HISTORIC DISTRICT COMMISSION NOTICE OF DENIAL

Application Number: HDC2025-00009

NAME: Caren Paskel		COMPANY NAME:	
ADDRESS: 3470 Cambridge	CITY: Detroit	STATE: MI	ZIP: 48221
PROJECT ADDRESS: 3470 Cambridge			
HISTORIC DISTRICT: Sherwood Forest

Replacement of steel and wood windows with vinyl-clad wood windows, and covering of wood rake boards, soffits and fascia with aluminum coil.

Old condition front elevation

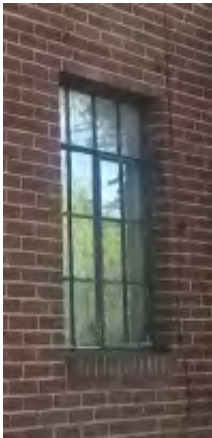
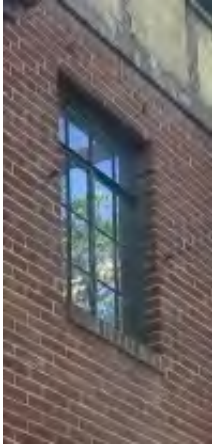
- The original windows were distinctive character-defining features.
 - o The thin frames of steel windows allow for more expansive glass surface, creating a striking visual contrast to the monolithic materiality of masonry-clad walls. The dimensional surface of the steel sash helped emphasize the verticality of the window openings, and in conjunction with the French doors on the front and rear walls, created a consistent rhythm on each side of the dwelling. Additionally, the multi-operational window openings are another distinctive feature and are a design feature found in only a few local historic districts. The steel windows offered a dimensionality and operation that was architecturally appropriate for the age and design of the house.

- o The operation of the windows were changed, obliterating the consistent verticality and rhythm of the window and door openings on the house. The majority of openings now have double-hung one-over-one windows; however, the larger openings on the front, west side, and rear have sliding units. The front sliders have between-the-glass grilles. Sliding windows and between-the-glass grilles are not consistent with the general characteristics of a historic window and do not match the dimensional quality of the removed historic steel window sash.

- o The placement of the new windows doesn’t match the more deeply recessed location of the historic windows within the window openings. The depth of plane change between window and wall surfaces is an important feature on the elevations of the house and the current windows don’t convey the same visual appearance.
